Current calculation for IEEE 802.3da Draft 1.0

Peter Fischer / BKS Kabel-Service AG

2/14/2024

Figure 169-1—Mixing segment and reference points

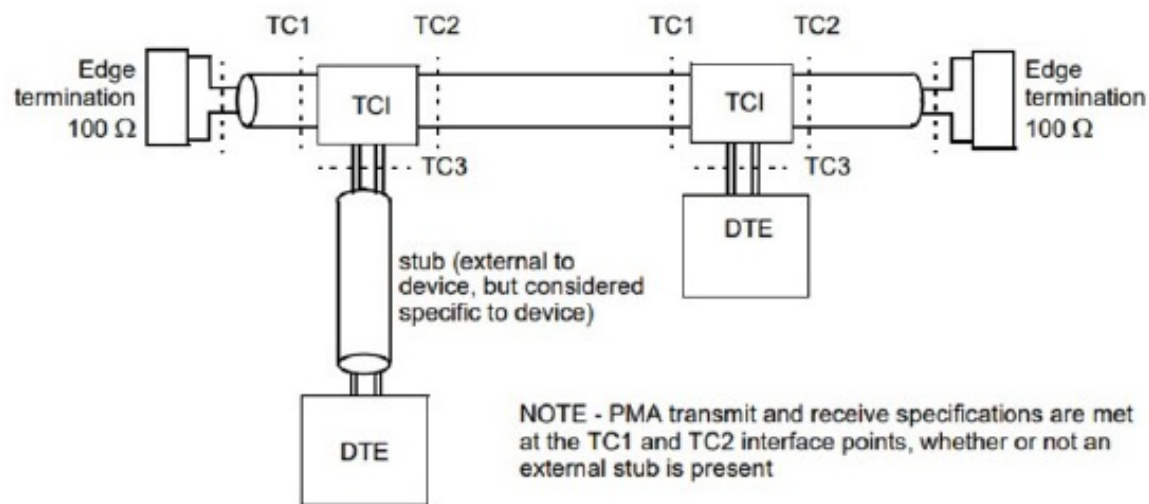
- One of the above DTE's is representing the MPD
- In worst case, the other DTE is representing a cluster with all MPD's
- Losses in the stub(s) are not considered

Mixing segment figure 169-1

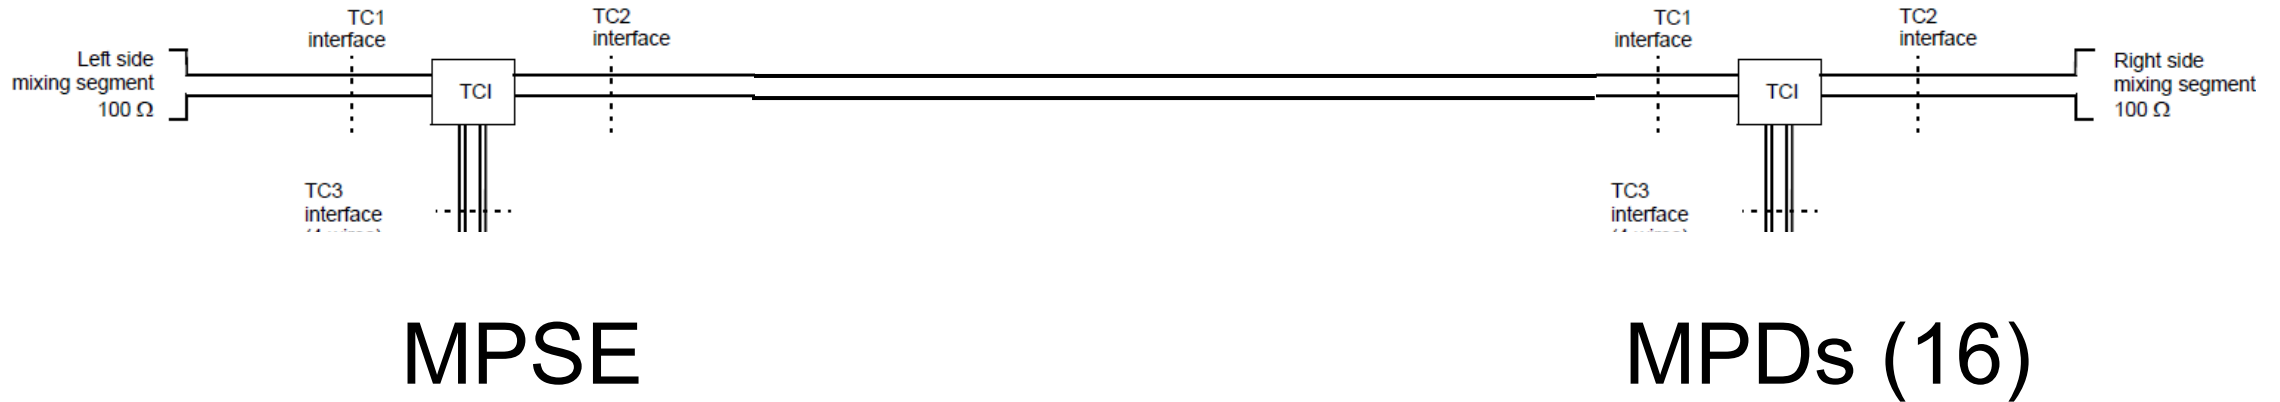
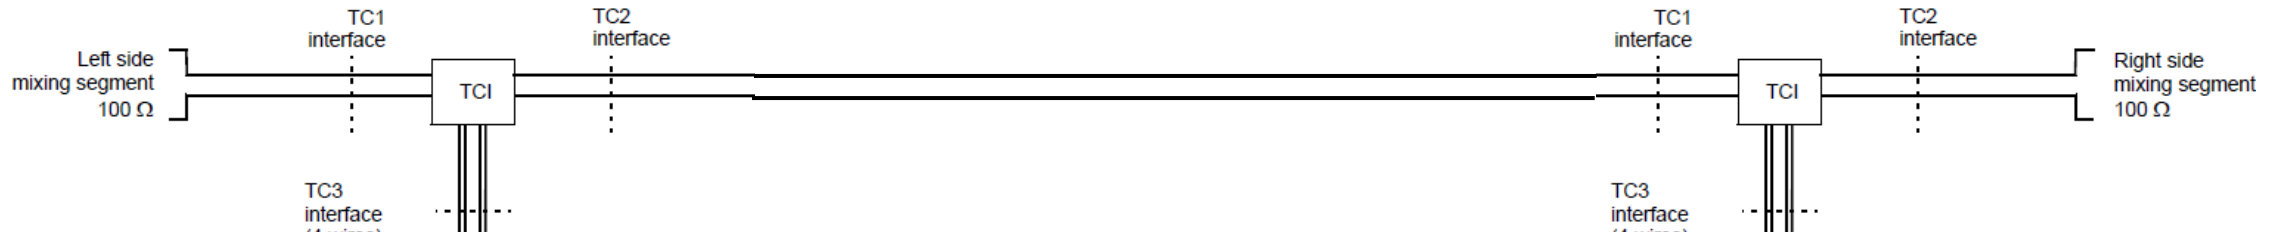
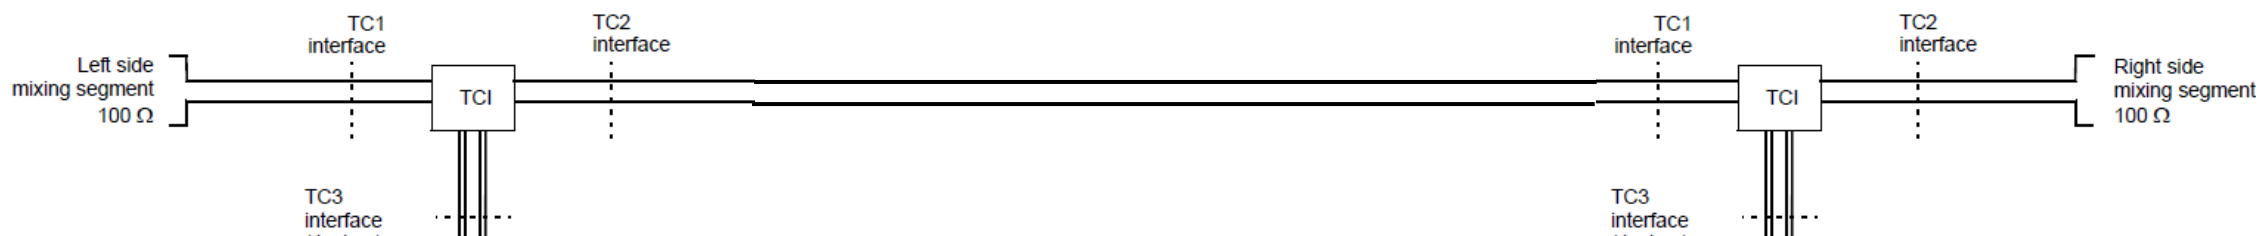
$$I_{PI(max) \text{ total}} = P_{MPD(total)} / V_{MPD(min)} = 32 \text{ W} / 34\text{V} = 941.176 \text{ mA}$$

$$\rightarrow I_{PI(max)} = I_{PI(max) \text{ total}} / 16 = 941.176 \text{ mA} / 16 = 58.823 \text{ mA}$$

To calculate $P_{\text{Type(min)}}$, we must consider the losses on the cable. The dc loop resistance of the mixing segment is 12 Ω.

$$P_{\text{Loss Mixing Segment}} = (I_{\text{PI(max) total}})^2 * R_{\text{DC Loop}} = (941.176 \text{ mA})^2 * 12 \Omega = 10.63 \text{ W}$$

$$P_{\text{Type(min)}} = P_{\text{MPD(total)}} + P_{\text{Loss Mixing Segment}} = 32 \text{ W} + 10.63 \text{ W} = 42.63 \text{ W}$$

Mixing segment figure 169-1

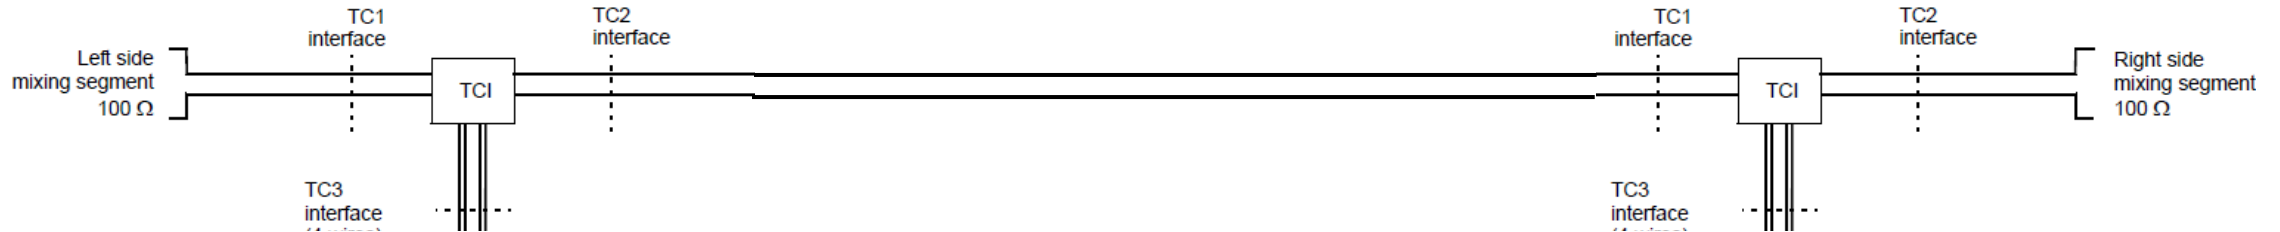
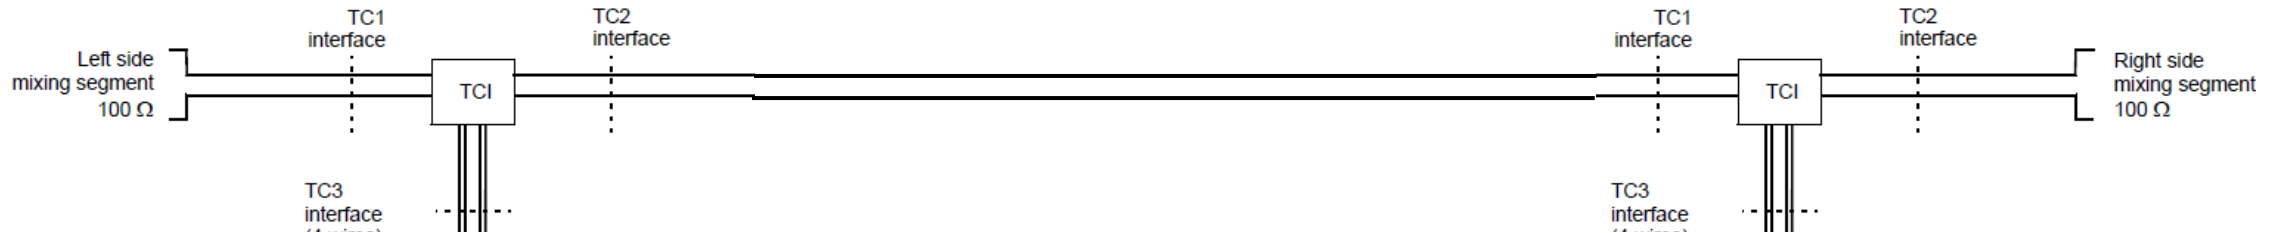
$$I_{PI(max) \text{ total}} = P_{MPD(total)} / V_{MPD(min)} = 16 \text{ W} / 18 \text{ V} = 888.889 \text{ mA}$$

$$\rightarrow I_{PI(max)} = I_{PI(max) \text{ total}} / 16 = 888.889 \text{ mA} / 16 = 55.556 \text{ mA}$$

To calculate $P_{\text{Type(min)}}$, we must consider the losses on the cable. The dc loop resistance of the mixing segment is 12 Ω.

$$P_{\text{Loss Mixing Segment}} = (I_{\text{PI(max) total}})^2 * R_{\text{DC Loop}} = (888.889 \text{ mA})^2 * 12 \Omega = 9.481 \text{ W}$$

$$P_{\text{Type(min)}} = P_{\text{MPD(total)}} + P_{\text{Loss Mixing Segment}} = 16 \text{ W} + 9.481 \text{ W} = 25.481 \text{ W}$$

The proposal is to add the above red marked values to the table 169-1.
